# DRI REGIONAL REVIEW FINDING

Name of Proposal: 425 Chappell Road DRI 4295 Submitting Local Government: City of Atlanta

<u>Description</u>: A DRI review of a proposal to construct a mixed-use development with 1,100 multi-family residential units and 5,000 SF of commercial space on an approximately 32-acre previously developed site at 425 Chappell Road in the City of Atlanta.

**DRI SITE PLAN**

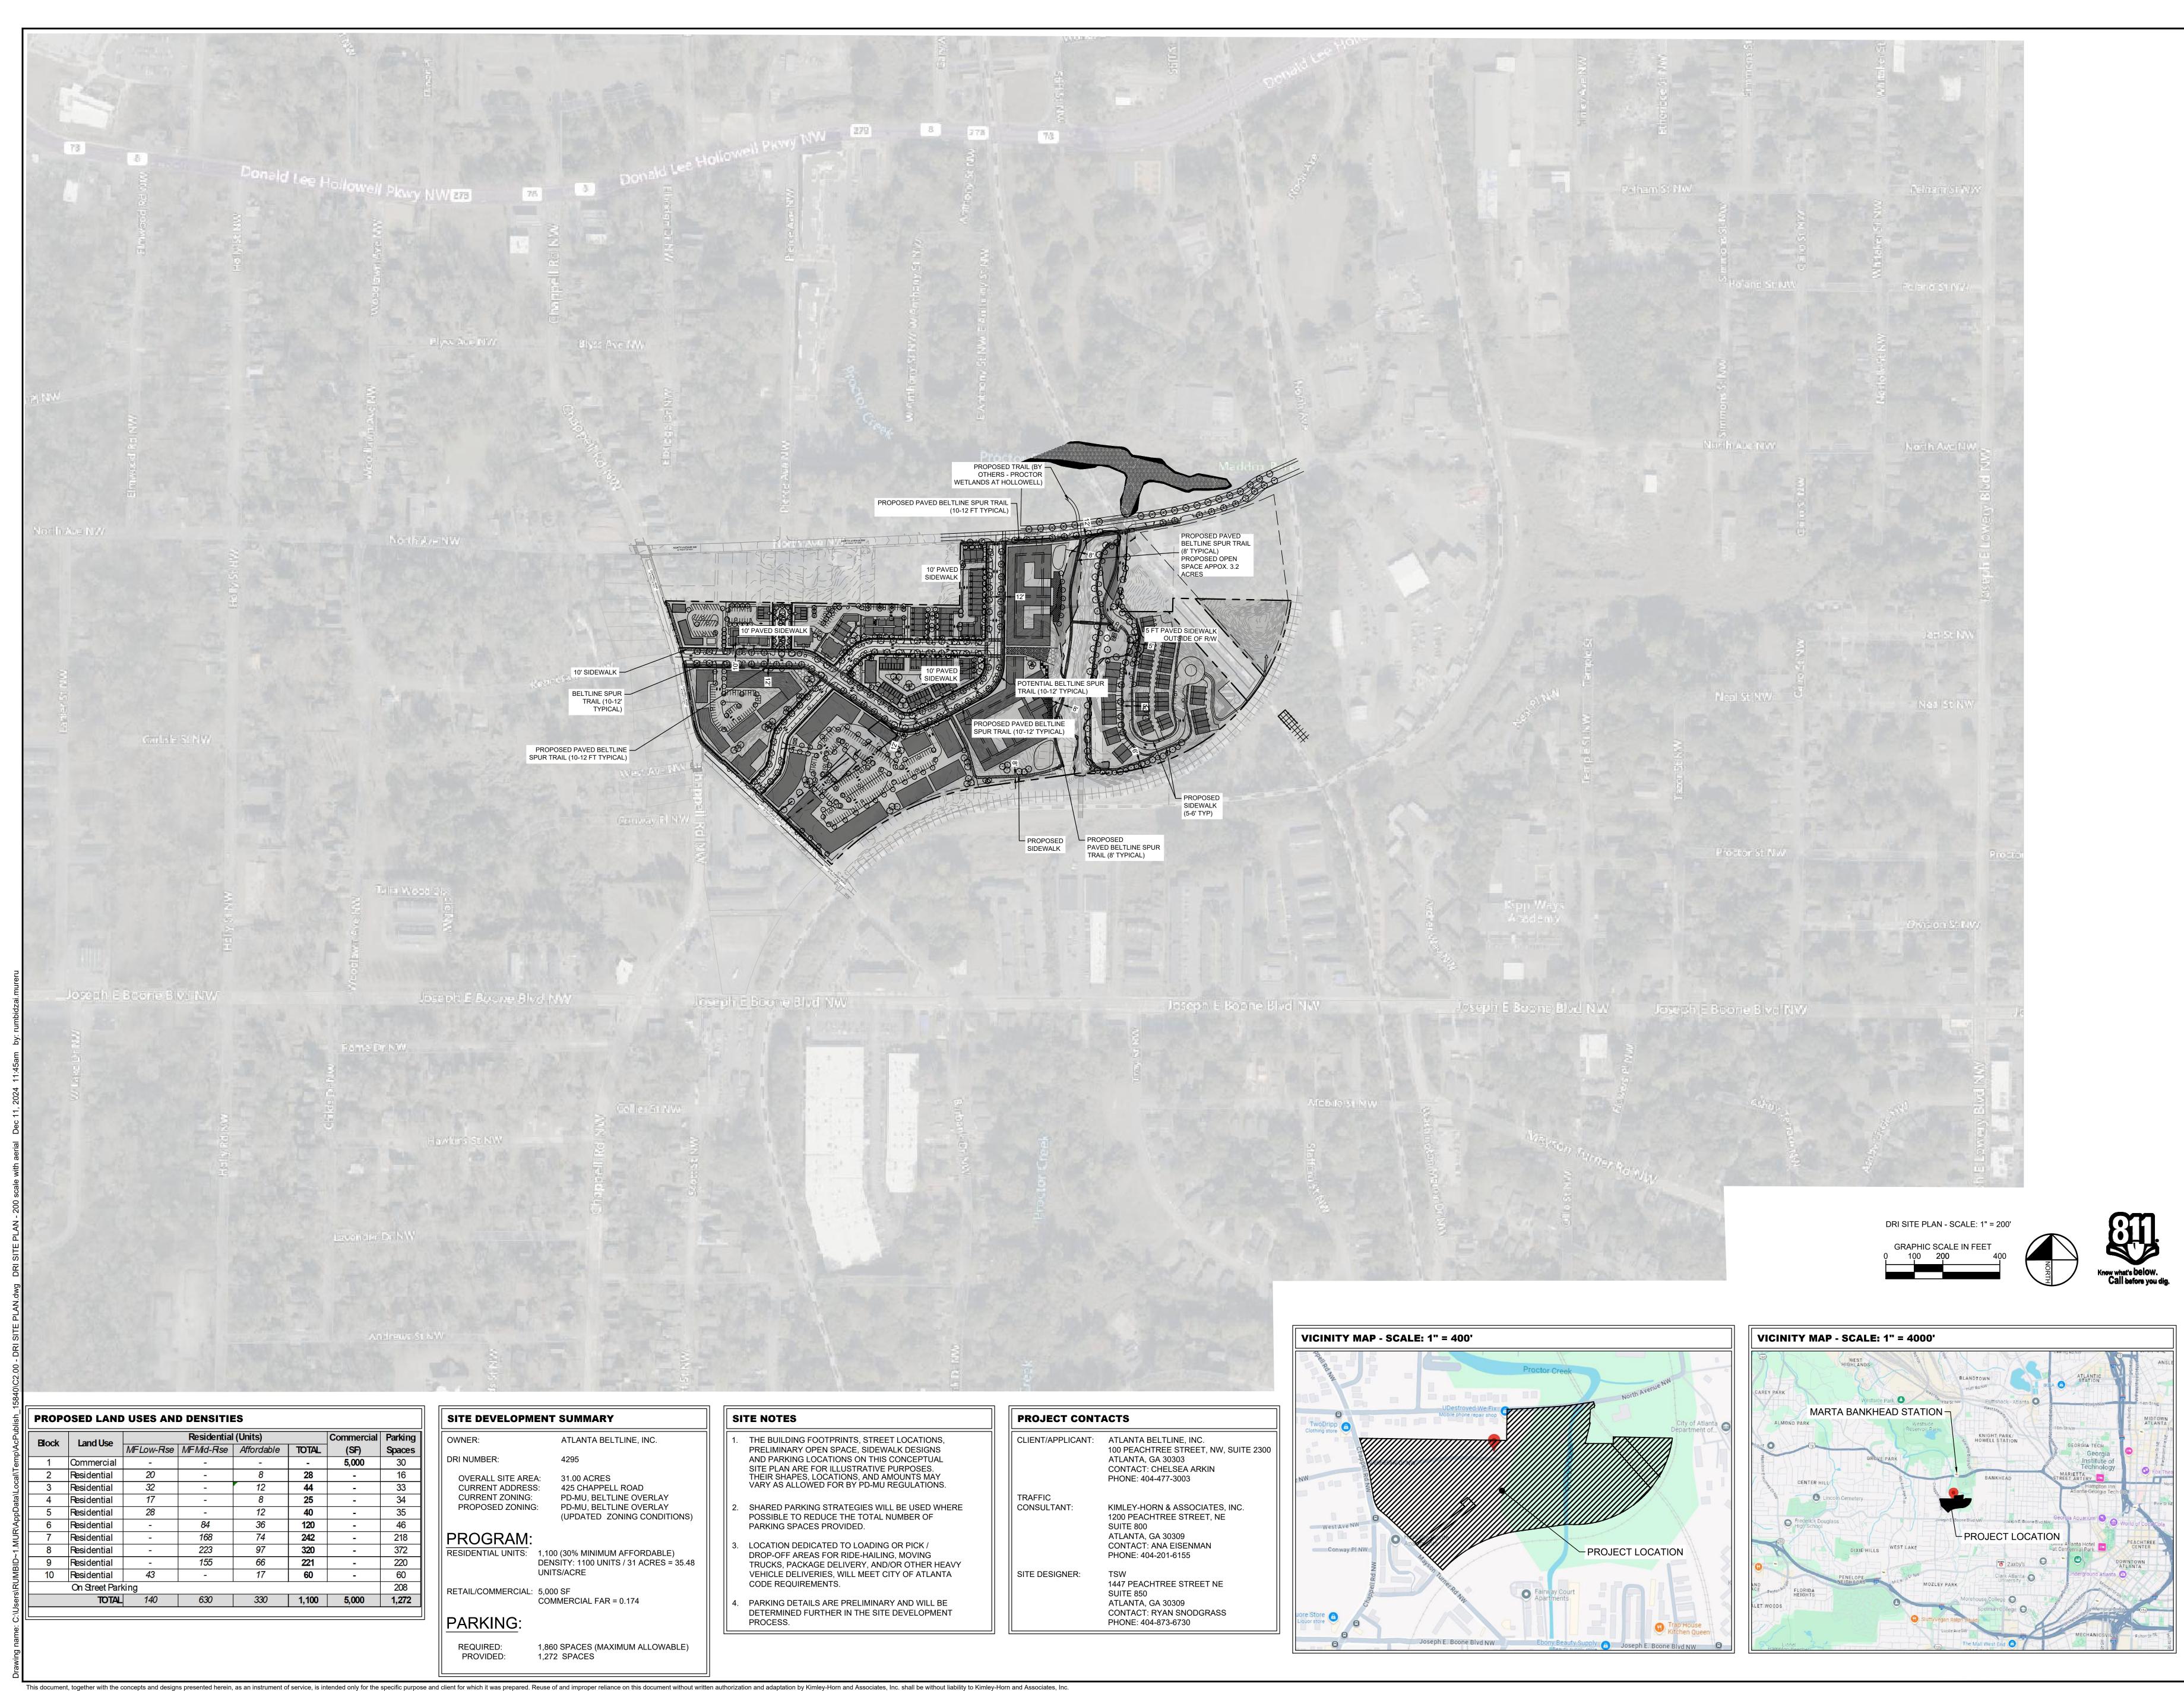
Some proposed elements extend into identified flood zones and other structures extend to the edge of these areas. As climate change induced extreme weather events grow in frequency, avoidance of areas at risk of flooding is strongly recommended.

Both the USGS coverage for the project area and the project site plan show Proctor Creek running south to north through the eastern end of the project property. Neither the USGS coverage nor the site plan show any other streams on the property. The State 25–foot Sediment and Erosion Control buffer is shown on the plans. The City's 75–foot natural vegetative buffer is shown, but as a 50–foot undisturbed buffer and additional 25–foot impervious setback. The submitted plan shows a proposed spur to the Beltline in the buffer on the west side of the creek and part of the internal sidewalk system on the east side of the Creek, with a proposed pedestrian bridge crossing the creek. The City Stream Buffer Ordinance does allow multiuse trails and transportation crossings in the buffer. It will be up to the City as to whether the sidewalk is covered by the exemption or if variances will be required. The submitted plan also shows a portion of access Driveway D intruding into the buffer on the east side of the property. In addition, structures and impervious surfaces are shown abutting the edge of the 75–foot buffer. Any intrusion into the buffer by impervious surfaces, or by grading related to their development, may require variances from the City of Atlanta.

The site plan shows both the 100-year floodplain, identified as Flood Zone AE and the 500-year floodplain, identified as Flood Zone X, for Proctor Creek. The areas shown are consistent with the current online FEMA floodplain maps. The site plan shows development within both flood zones, including the proposed Beltline spur, the proposed pedestrian bridge, sidewalks, terraces, a portion of the east access drive and a small parking area and kiosk at the proposed pedestrian bridge. Development within the floodplain areas will need to meet all applicable requirements under the City's floodplain and future floodplain ordinances. Some proposed townhomes extend into identified flood zones and other structures extend to the edge of these areas. While these areas may be identified as having a lower flood risk in current flood maps, flood risks overall are increasing significantly with climate change induced extreme weather impacts. Avoidance of areas at risk of flooding is strongly recommended.
